Addendum 02

Date: 05-21-2026
Project: 22011 – Spin Lofts
 521 21st Ave
 Council Bluffs, IA

Spin Lofts
TD2#: 748-886
Addendum 2
05/15/2026

G5 PLAN DETAIL - INSIDE CORNER AT METAL PANEL
A5.4 SCALE: 1 1/2" = 1'-0"

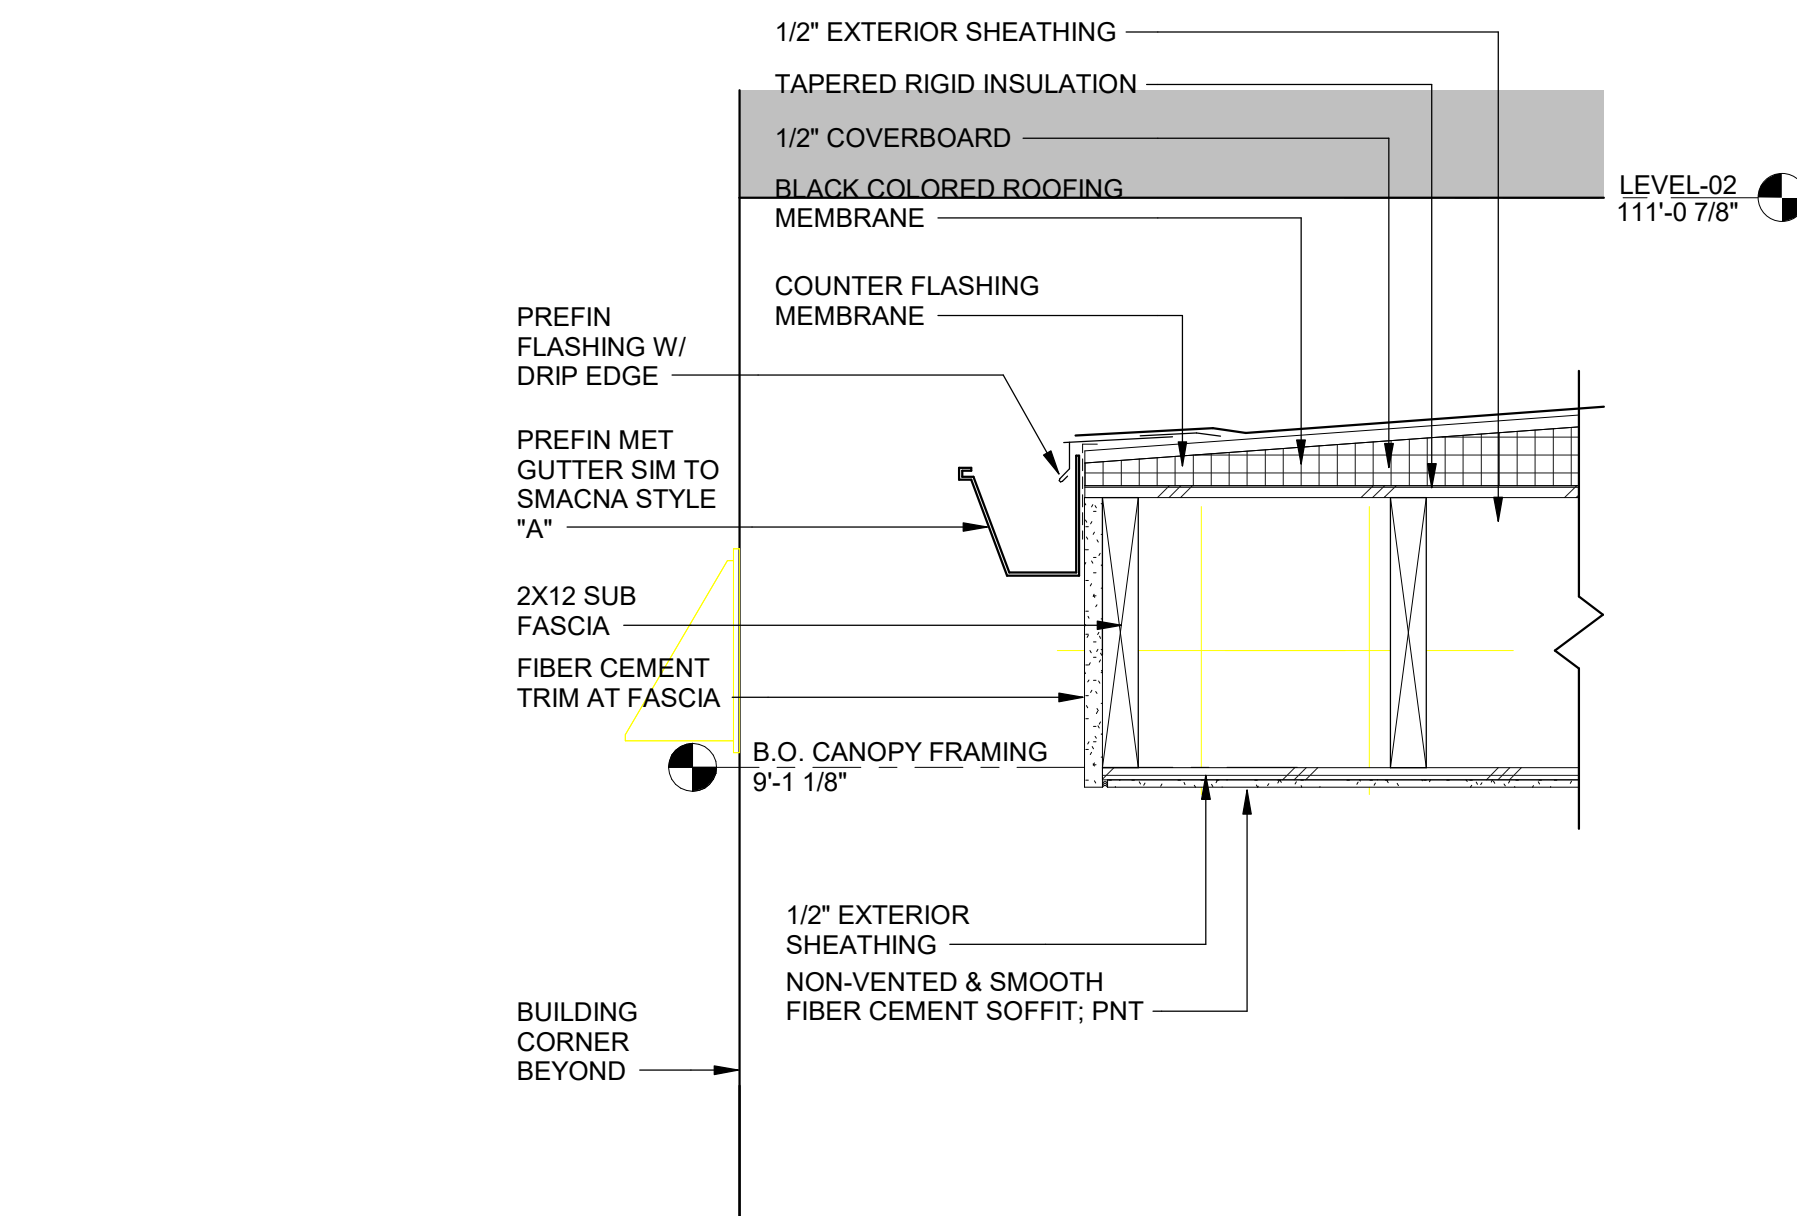
10. Sheet A5.4: BUILDING DETAILS
 - a. Add notes to details D5, G5, and D15.
11. Sheet A8.4: ENLARGED PLANS & ELEVATIONS – UNIT 2A
 - a. Revise door swing at unit mechanical closet.

F8 ENLARGED UNIT PLAN - UNIT TYPE 2B (TYPE B)
A8.6 SCALE: 1/4" = 1'-0"

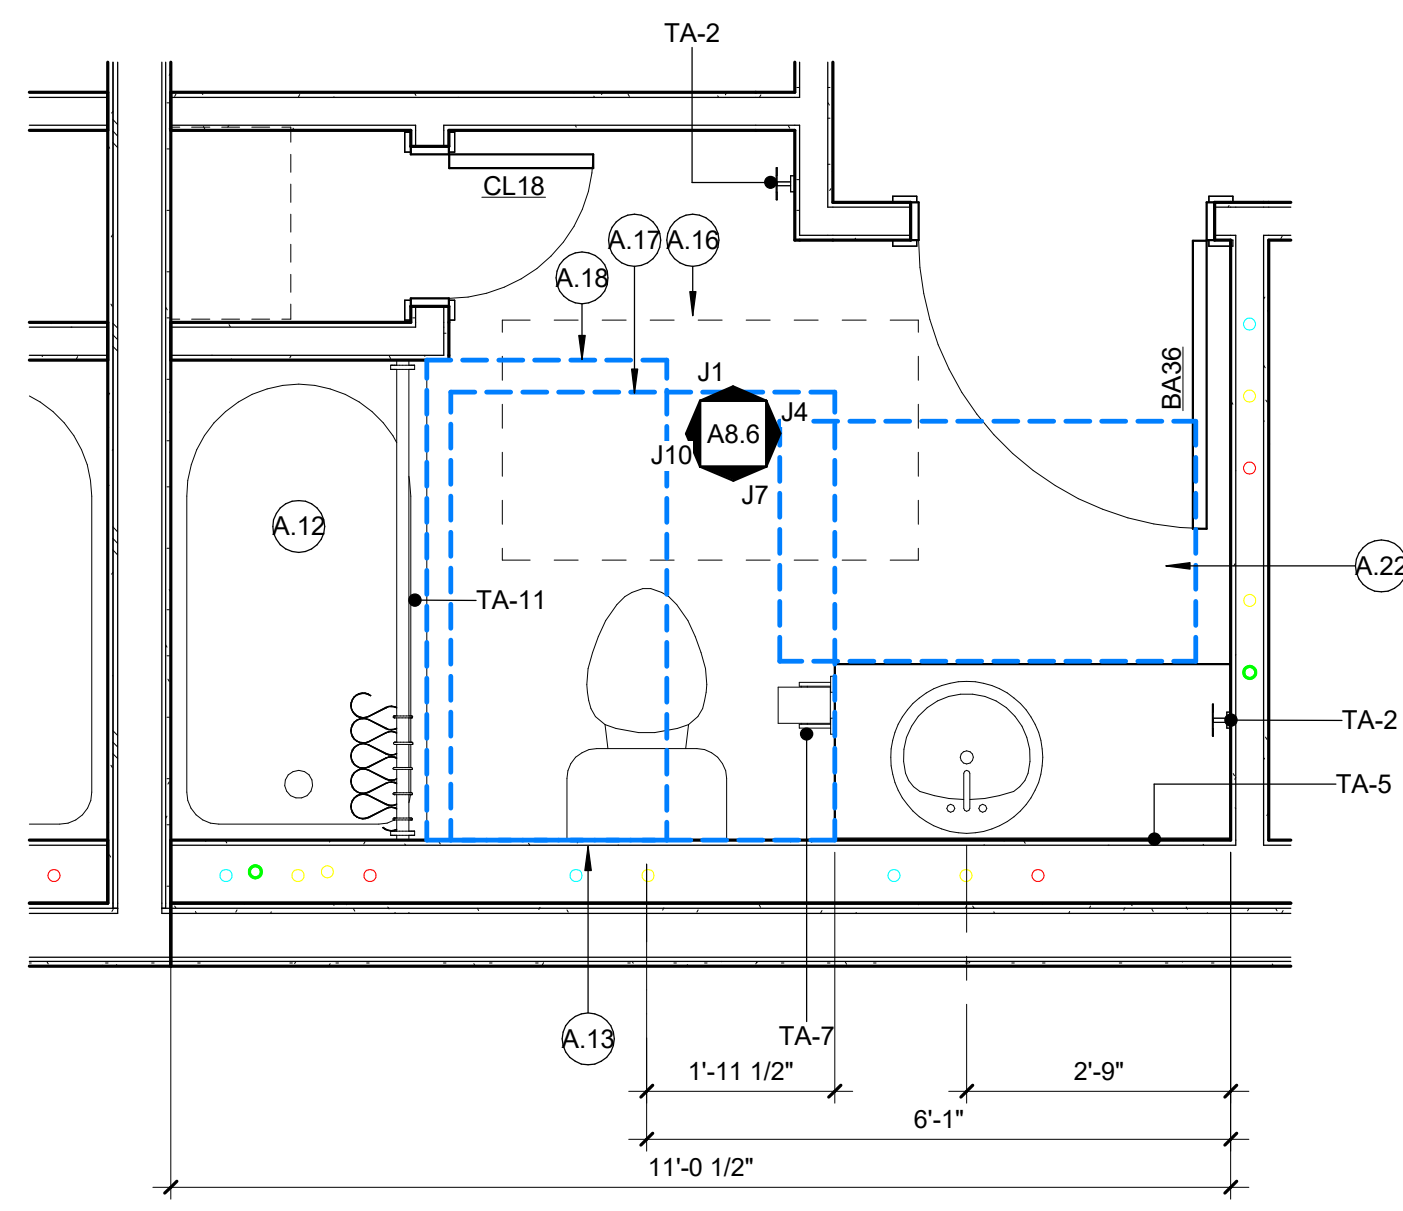
- a. Revise door swing at unit mechanical closet.
14. Sheet A8.7: ENLARGED PLANS & ELEVATIONS – UNIT 2B.1
 - a. Revise door swing at unit mechanical closet.

F8 ENLARGED UNIT PLAN - UNIT TYPE 2C.1 (ACCESSIBLE)

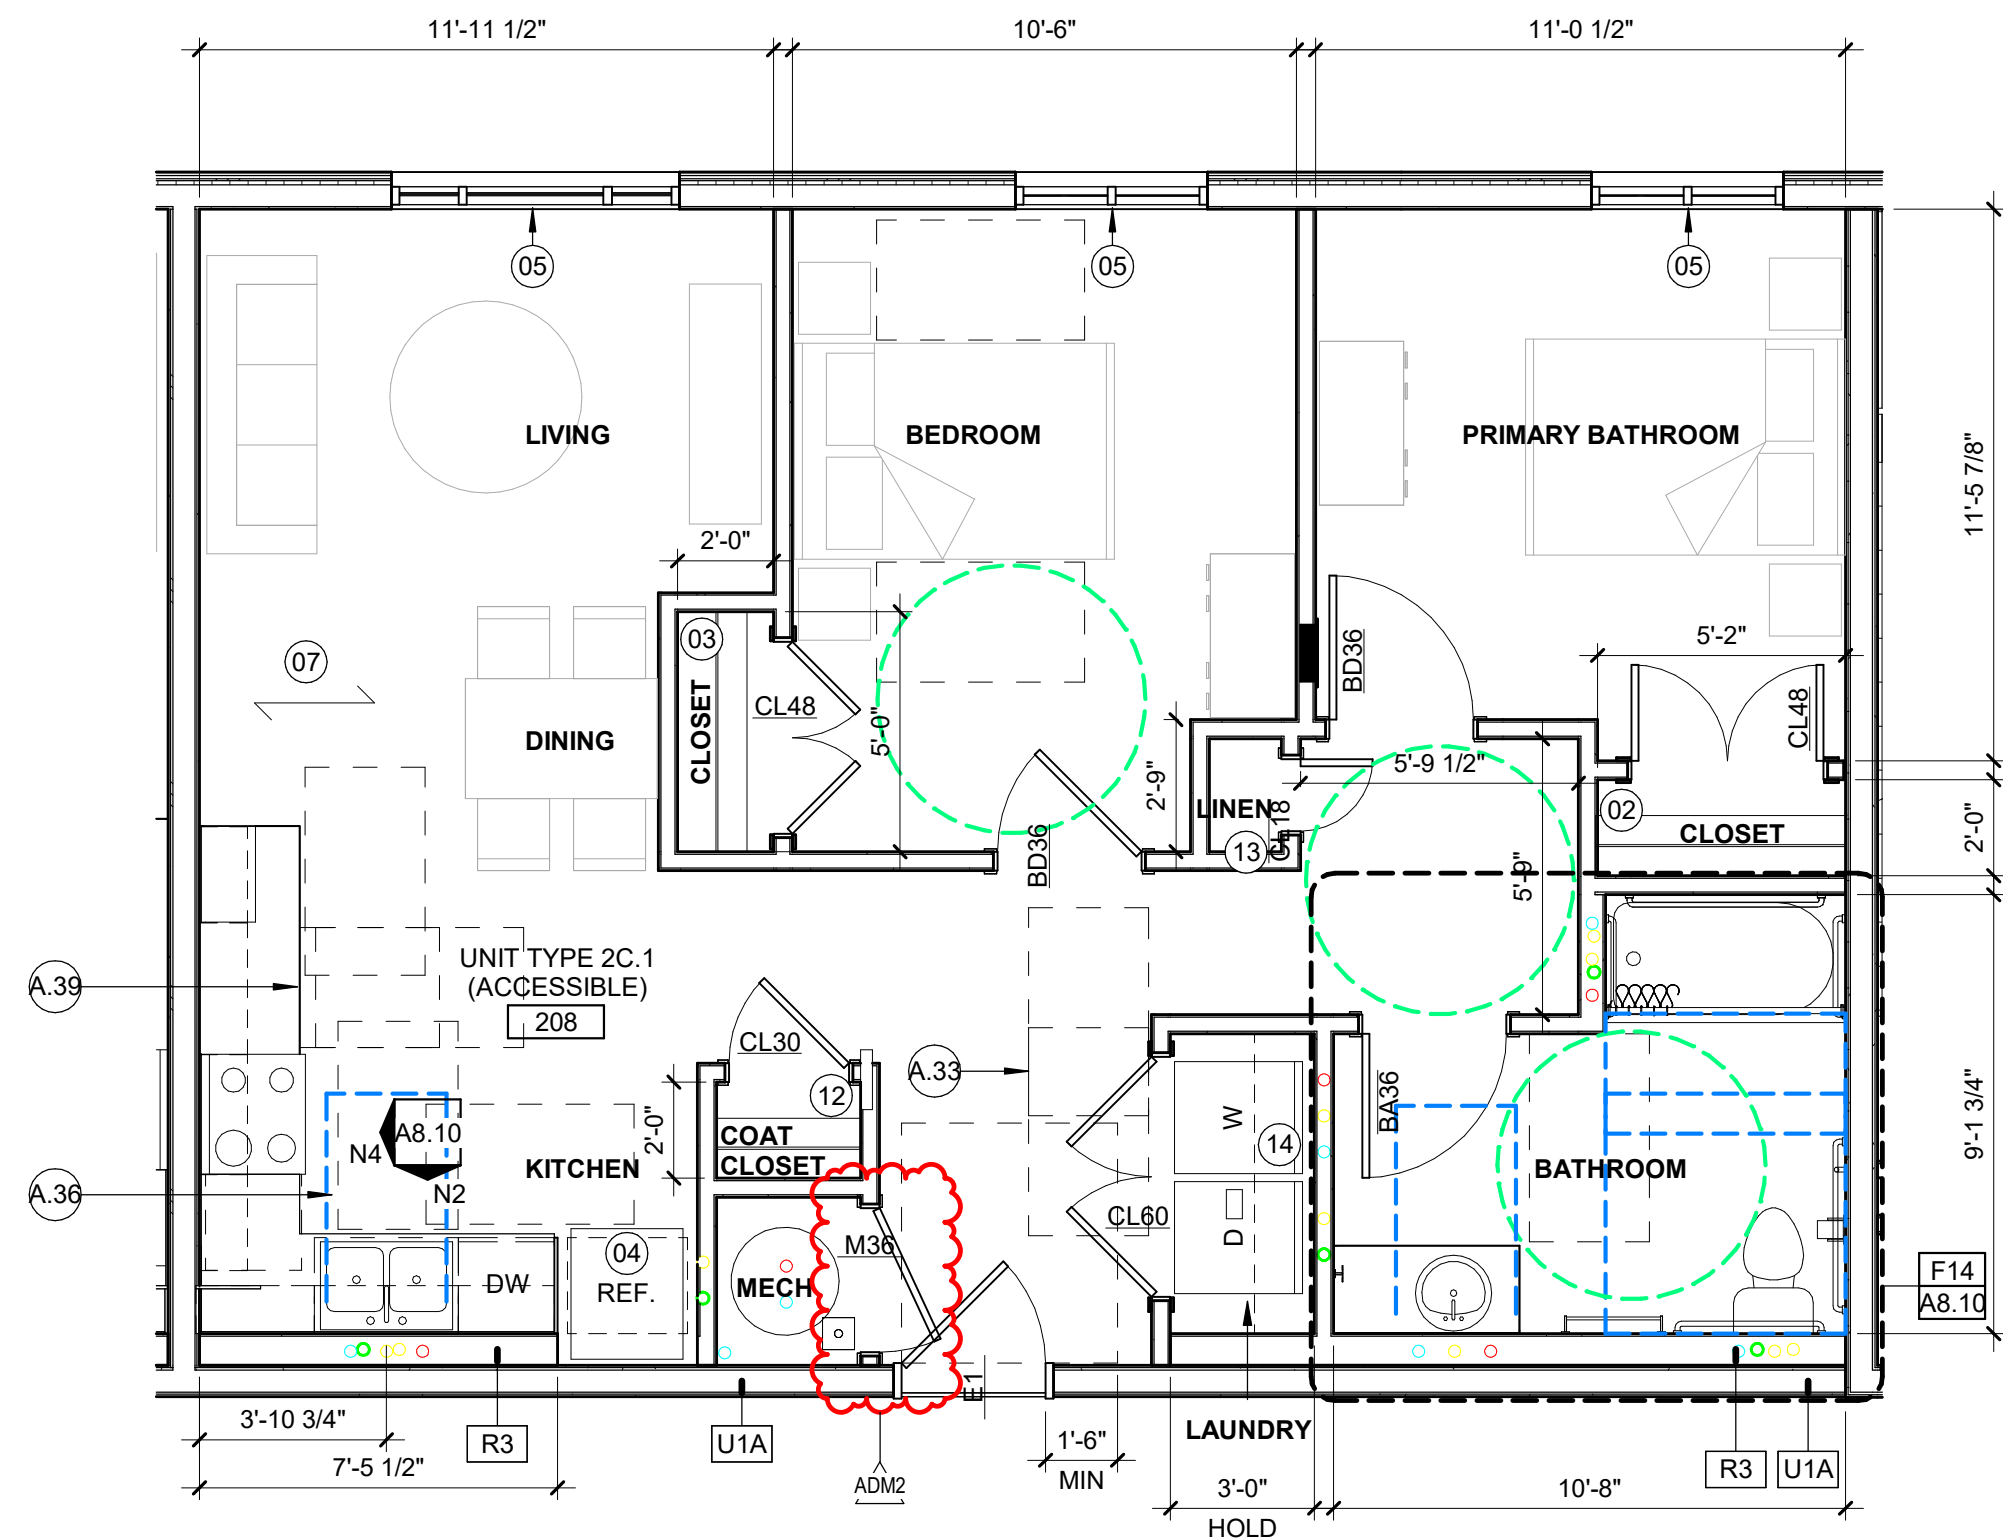
- a. Revise door swing at unit mechanical closet.
17. Sheet A8.10: ENLARGED PLANS & ELEVATIONS – UNIT 2C.1
 - a. Revise door swing at unit mechanical closet.

F9 ENLARGED UNIT PLAN - UNIT TYPE 3A (TYPE A)
A8.11 SCALE: 1/4" = 1'-0"

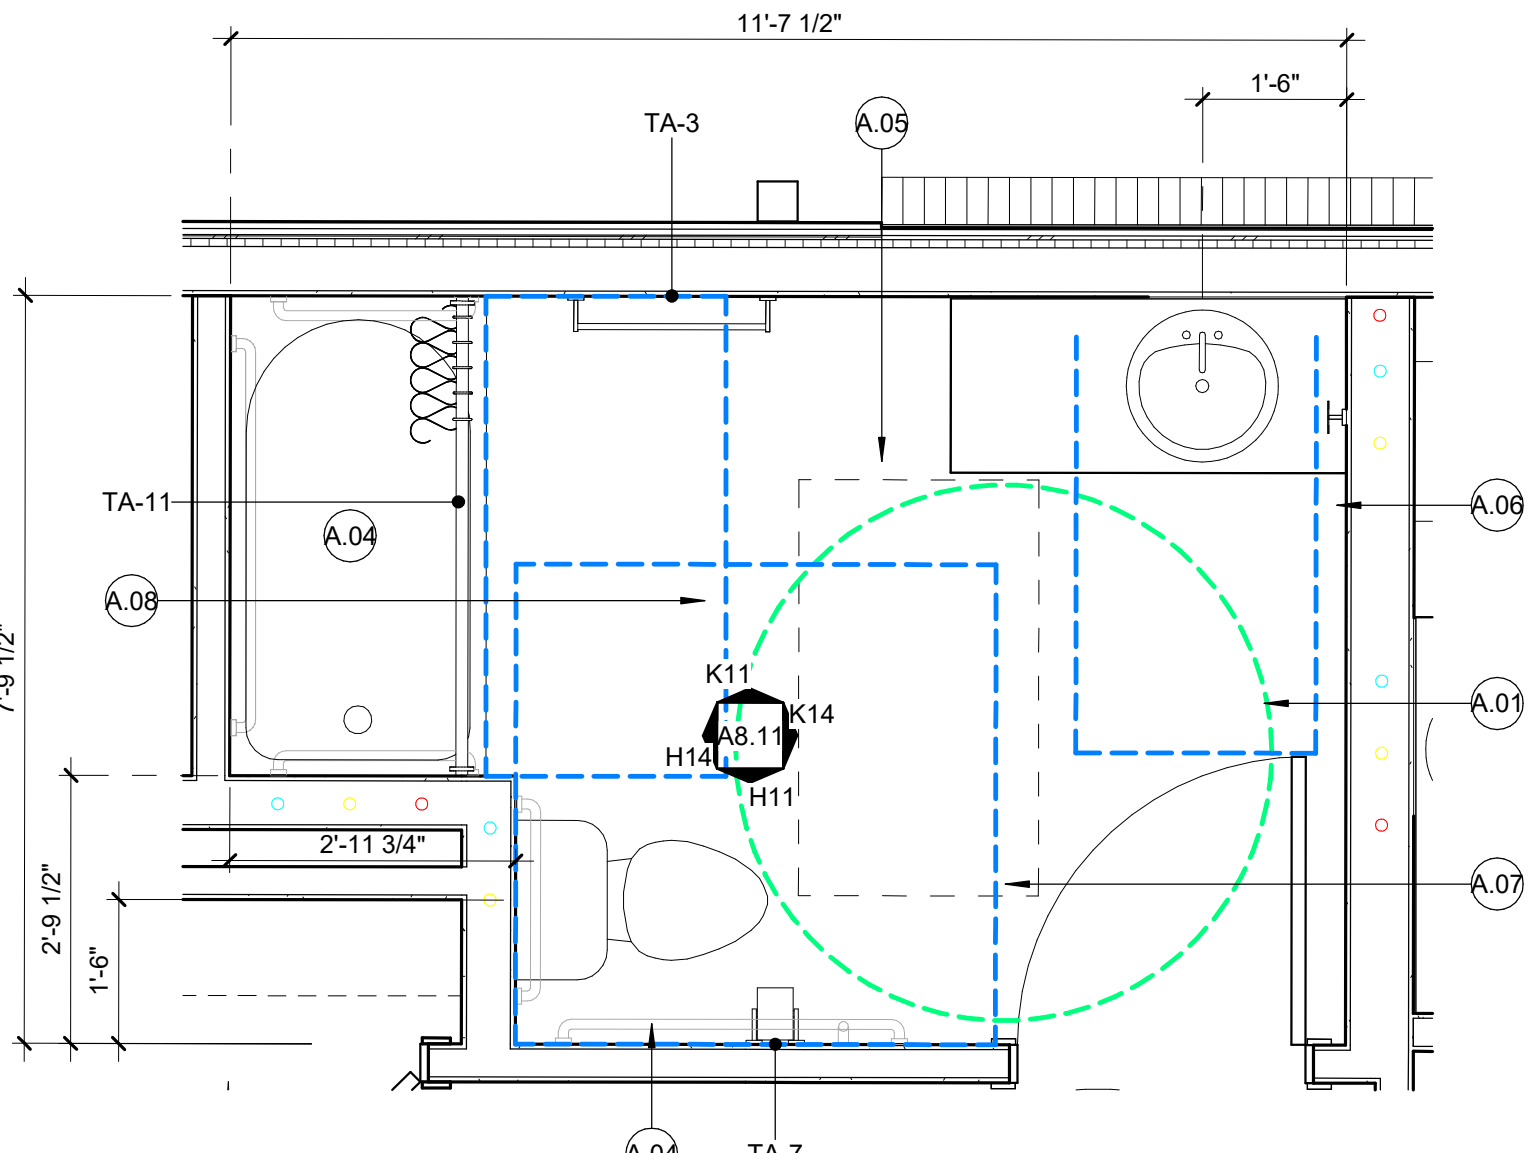
18. Sheet A8.11: ENLARGED PLANS & ELEVATIONS – UNIT 3A
 - a. Revise door swing at unit mechanical closet.
19. Sheet A8.12: ENLARGED PLANS & ELEVATIONS – UNIT 3C

F8 ENLARGED UNIT PLAN - UNIT TYPE 3C (ACCESSIBLE)
A8.12 SCALE: 1/4" = 1'-0"

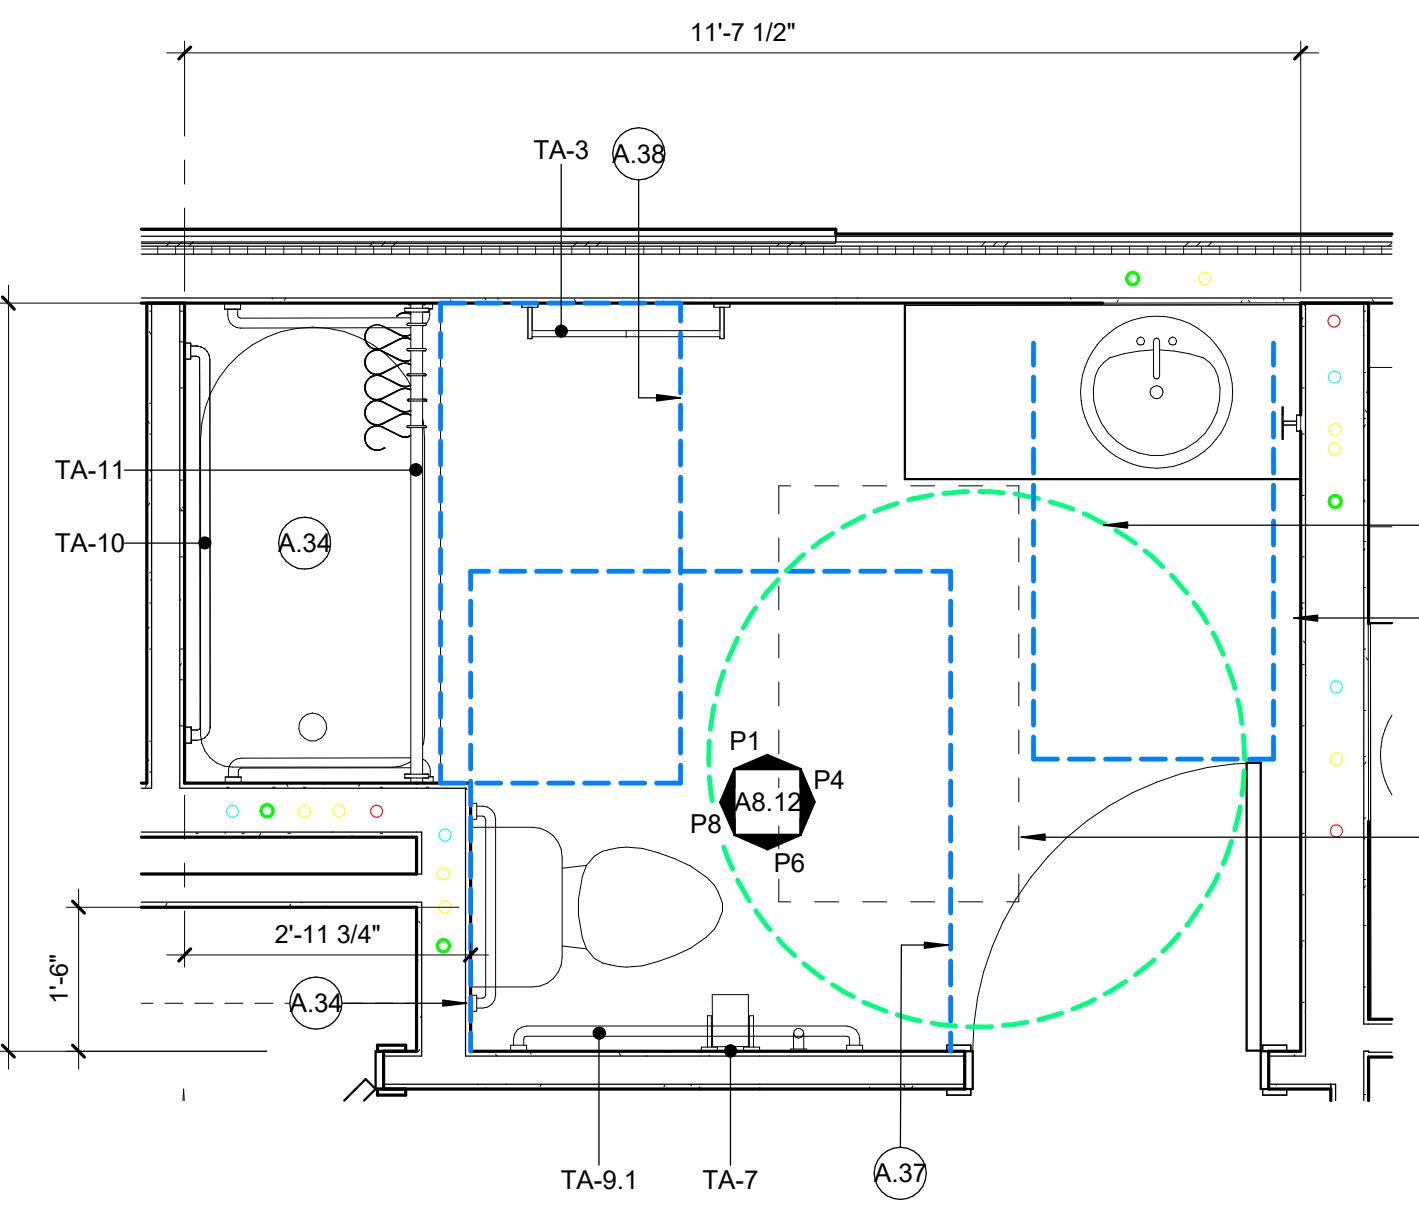
- a. Revise door swing at unit mechanical closet.
